Model:Stella-C1

No.: MB044001

Modified Article: Parts catalog correction

From: Technical Services sec. Service Planning Dept.

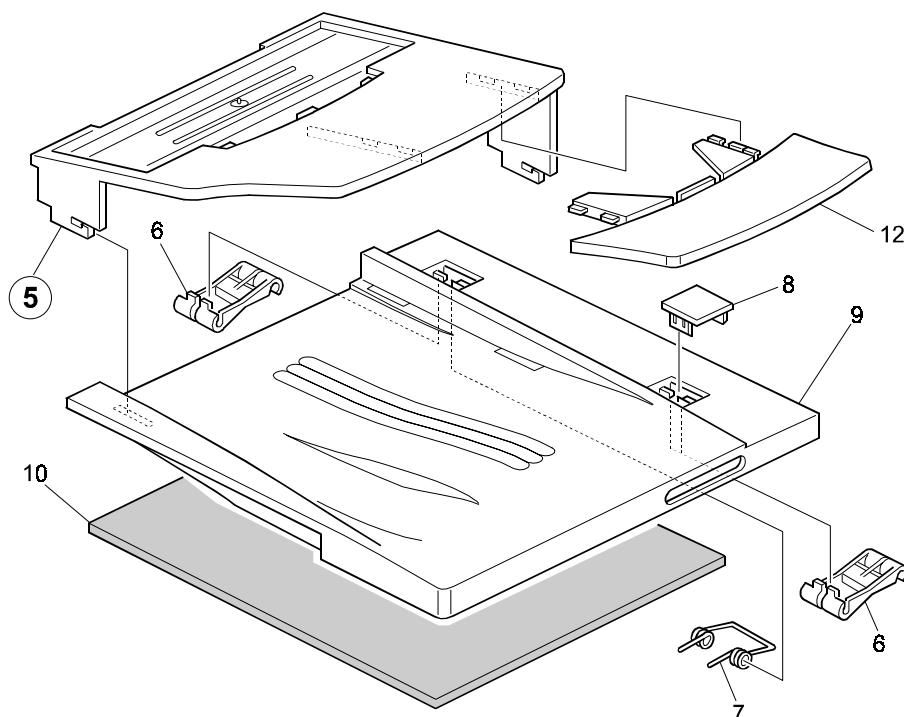
- Please CORRECT the following (pg. 18):
 Incorrect: In the illustration below, index #5 and #9 both point to the Platen Cover.
 Correct: Index #9 is for the Platen Cover, and index #5 is for the Original Table (B0444948).

1.Printer Controller (B441)

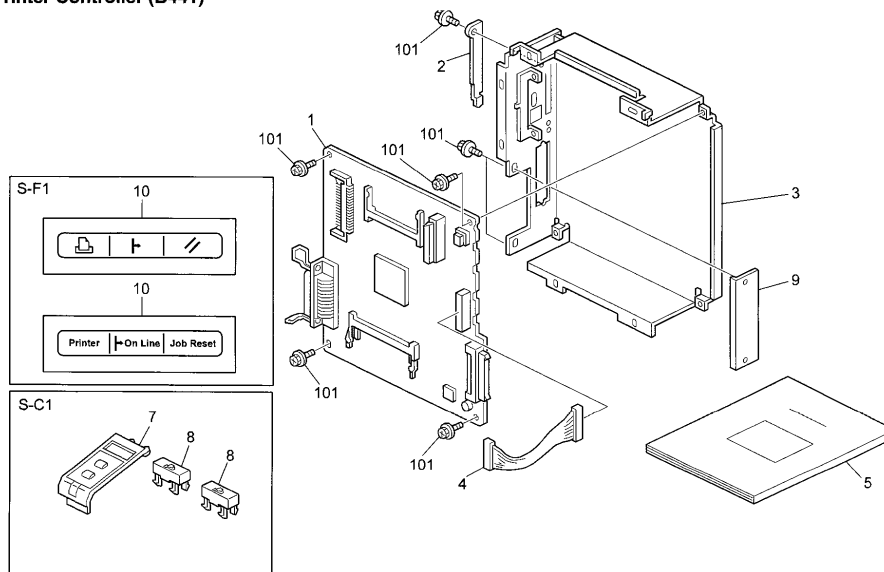
The following P/N have been changed due to parts standardization of the printer option for the S-C1 and S-F1.

| Old part number | New part number | Description | Q'ty | Int | Page | Index | Note |
|-----------------|-----------------|----------------------------------|------|-----|------|-------|------|
| B4415170 | B4415175 | Controller Board S-C1/F1 | 1→1 | * | 3 | 1 | 1 |
| B4418607 | B4418857 | Operation Manual – REF-1 English | 1→1 | * | 3 | 5 | 1 |
| B4058594 | | CD ROM (NRG) | 1→0 | -- | 3 | 6 | 2 |
| B4418595 | | CD ROM (INF) | 1→0 | -- | 3 | 6 | 2 |
| B4418596 | | CD ROM (LAN) | 1→0 | -- | 3 | 6 | 2 |
| | B4411456 | Printer Decal – S-F1 : NA/Asia | 0→1 | -- | 3 | 10 | 3 |
| | B4411457 | Printer Decal – S-F1 : EU | 0→1 | -- | 3 | 10 | 3 |

- The interchangeability between these two parts is as follows:
Both can be used with the S-C1 printer, but the old part cannot be used with the S-F1 printer.
- This P/N change information was previously announced in MB044001.
- These parts are unique to the S-F1.

1. Printer Controller (B441)

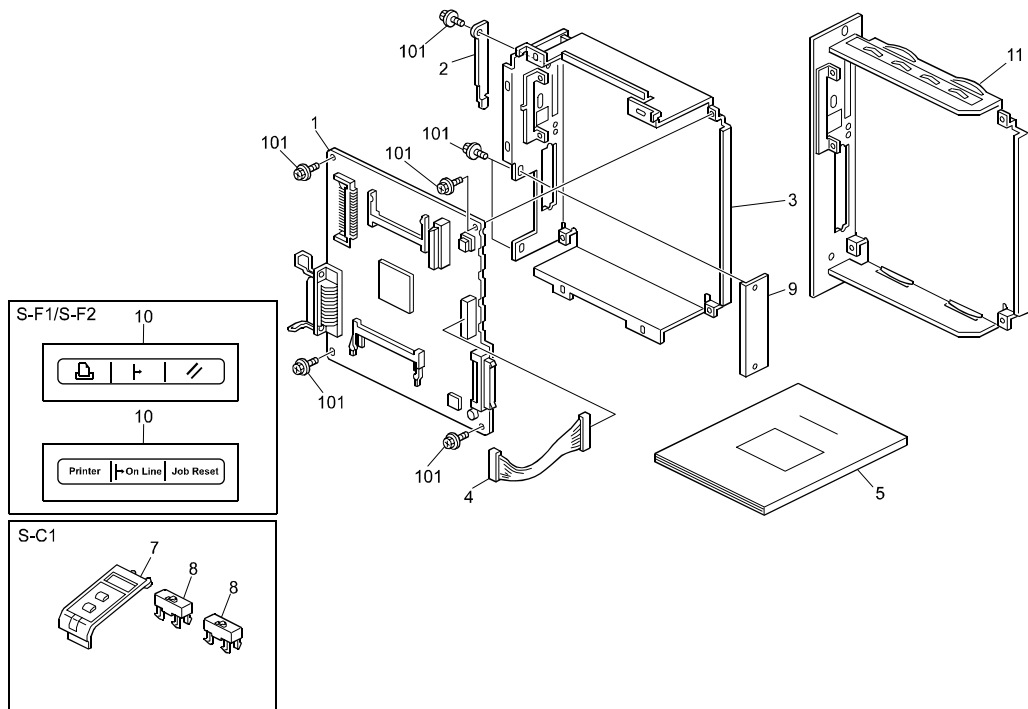
The following P/N have been changed due to parts standardization of the printer option for the S-C1/F1 and S-F2.

| Old part number | New part number | Description | Q'ty | Int | Page | Index | Note |
|-----------------|-----------------|------------------------|------|-----|------|-------|------|
| B4415175 | B4415162 | Controller Board | 1→1 | * | 3 | 1 | 1 |
| B4418857 | B4418877 | Operation Manual | 1→1 | * | 3 | 5 | 1 |
| | B4415801 | Printer Bracket - S-F2 | 0→1 | -- | 3 | 11 | 2 |

1. The interchangeability between these two parts is as follows:
Both can be used with the S-C1/F1 printer, but the old part cannot be used with the S-F2 printer.
2. This part is unique to the S-F2.
